**OIL INDIA LIMITED
KG BASIN PROJECT
KAKINADA**

**AMENDMENT No. 1 Dated 23.08.2022 TO
TENDER No. CEI1059P23**

IFB No. CEI1059P23 for 'Hiring of Geophysical and Geotechnical Investigation surveys for Offshore Block KG/OSDSF/GSKW/2018'

Bidders' Queries & Client's Responses

ENLARGED VIEW OF PLATFORM SURVEY GRID-EAST PLATFORM

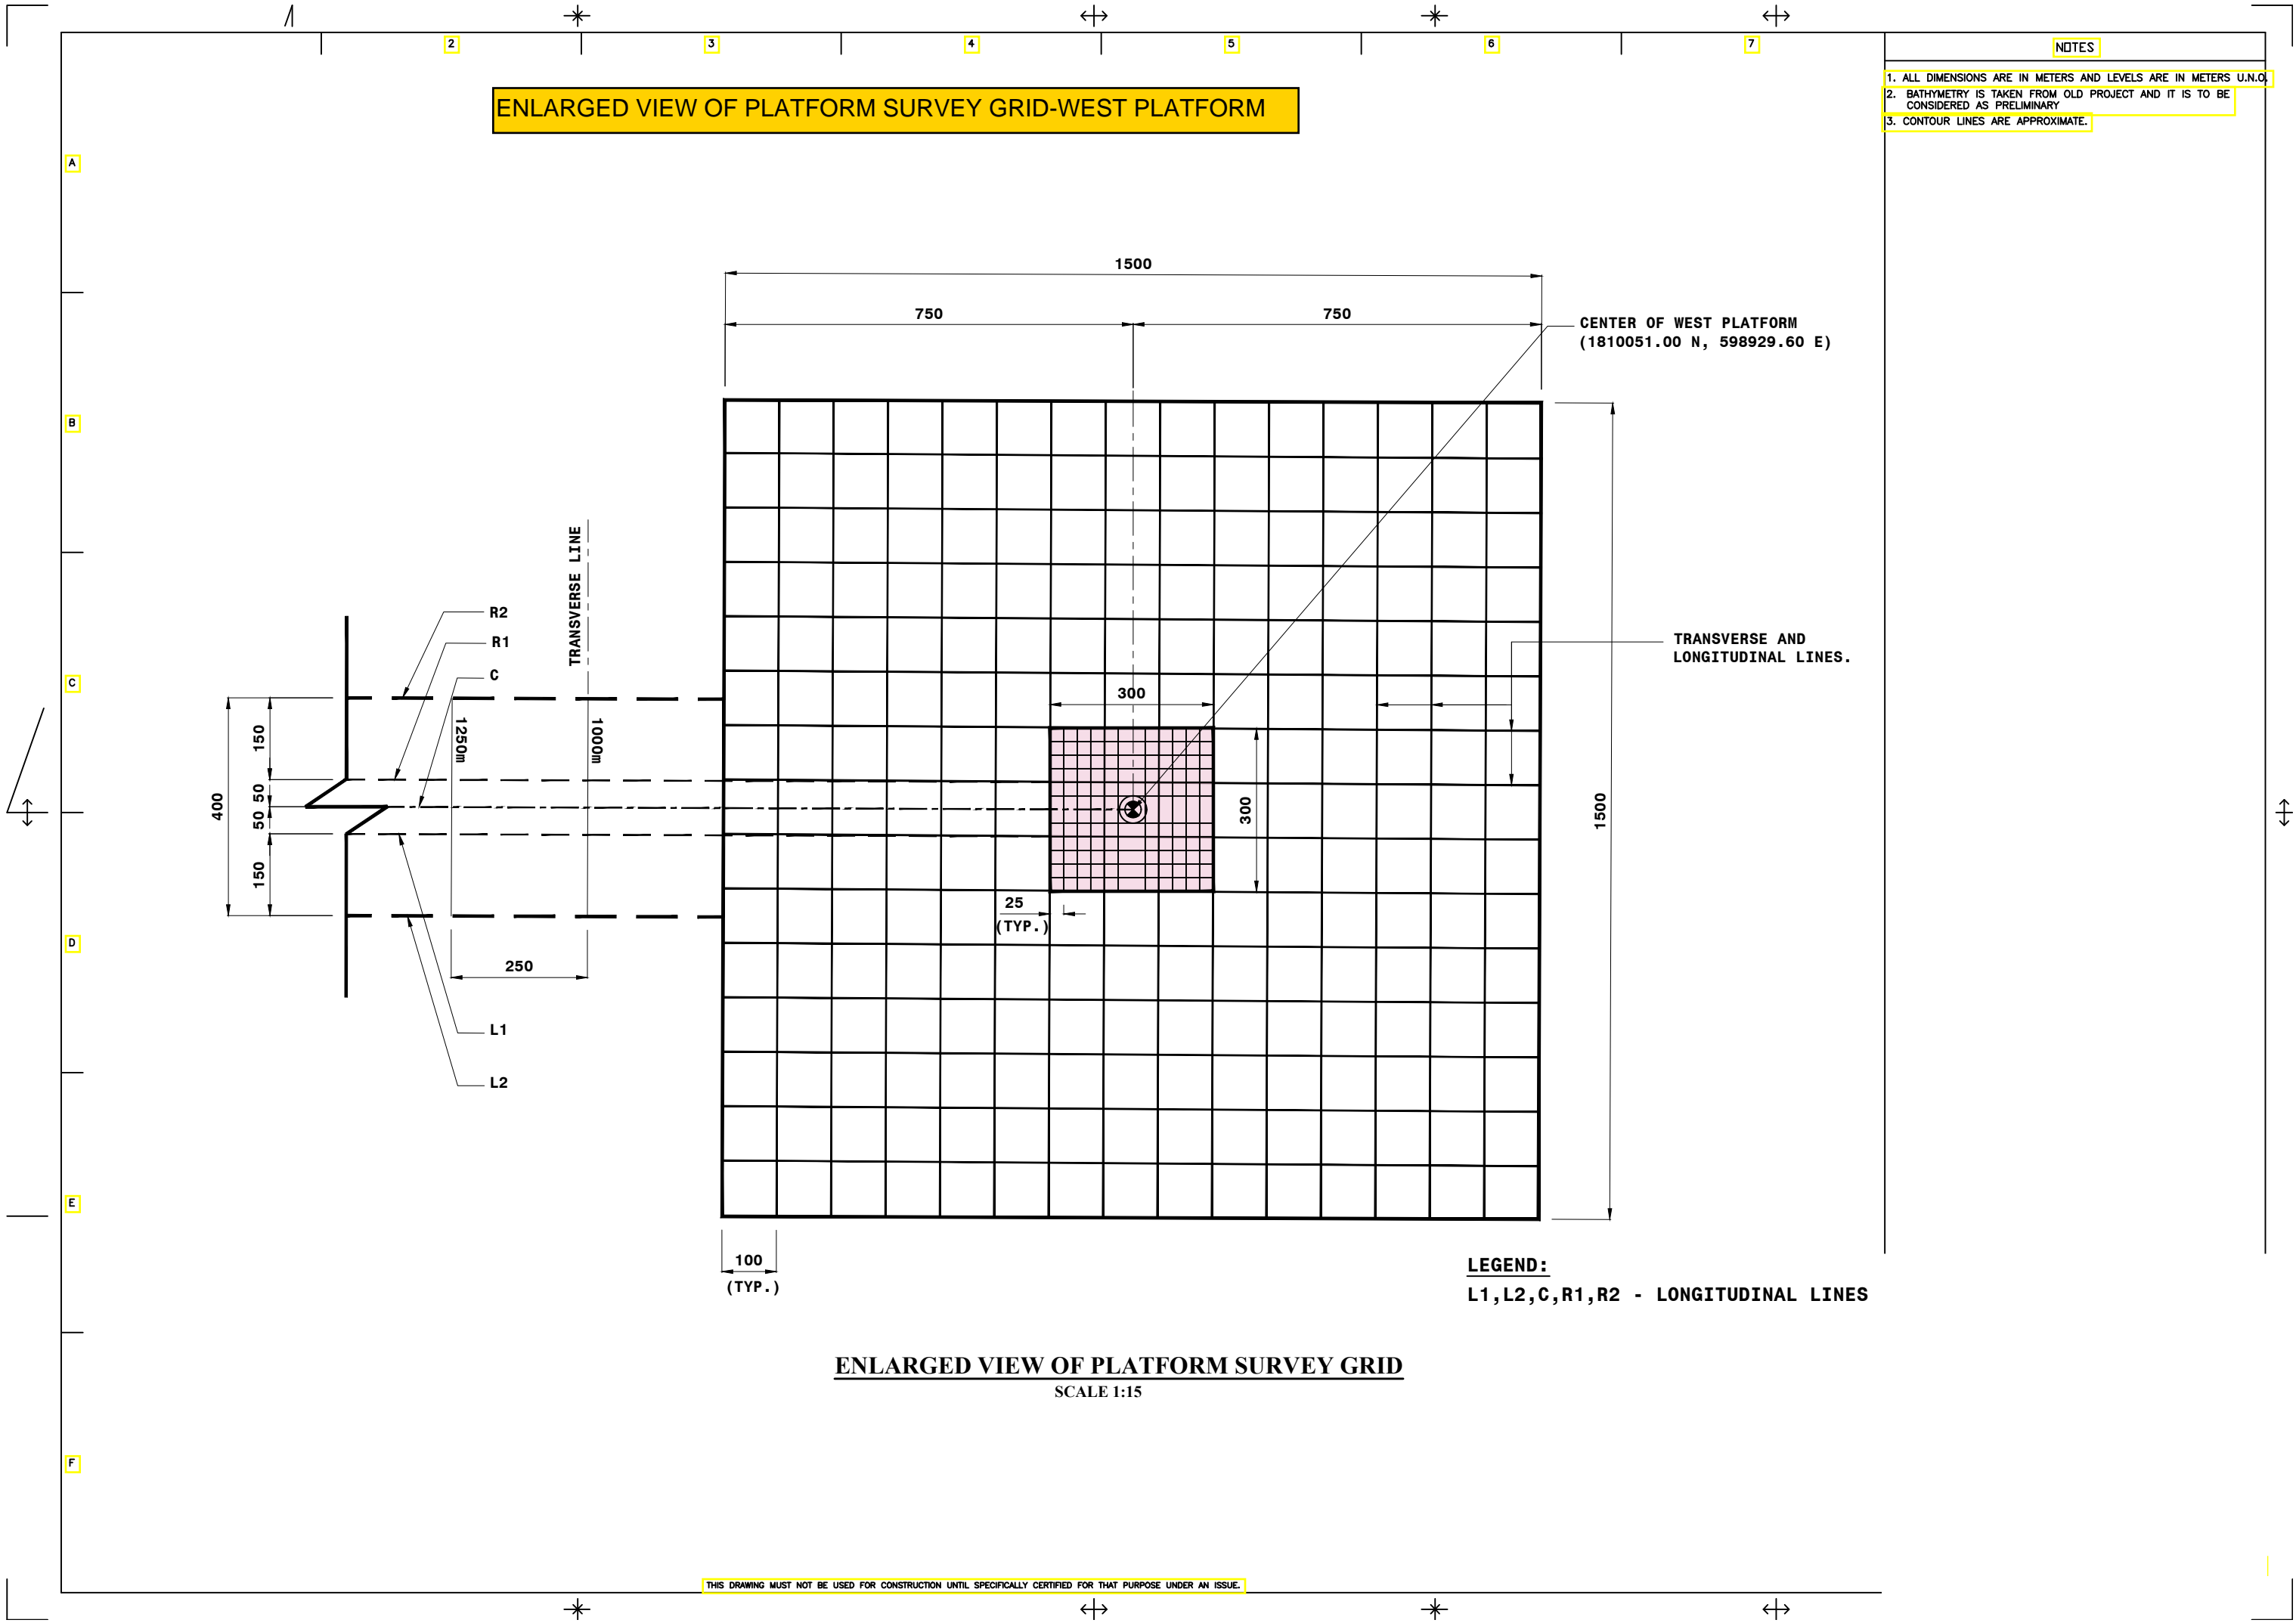
3.	General	Coordinates of BH and PCPT locations	Please provide the BH and PCPT location coordinates in WGS 84 for better understanding.	Coordinates are provided in the attached drawings. The distance between BH and PCPT shall not exceed 3m.

6.	Part 3, Section-2, PART-B: Geophysical Surveys, Survey Requirement sub clause (i) Page 84 of 200	"...Pre-engineering surveys for platform locations shall consists of bathymetric survey for area covering 1.5 km x 1.5 km with grid spacing of 100 m x 100 m in NS-EW direction. In addition to overall 100m x 100m survey in the overall area..."	<p>The estimated water depth is in the order of 5m to 15m. 100m line spacing would lead to data gap. Please advise 100% seabed coverage of Multibeam bathymetry data is requirement.</p> <p>If 100% seabed coverage in data is required, contractors are to run additional lines and hence more time will be required.</p> <p>Please confirm acceptance.</p>	<p>Not acceptable. Bidder shall follow specification clause B.2(i).</p> <p>Refer to attached drawings for details of line spacing.</p>
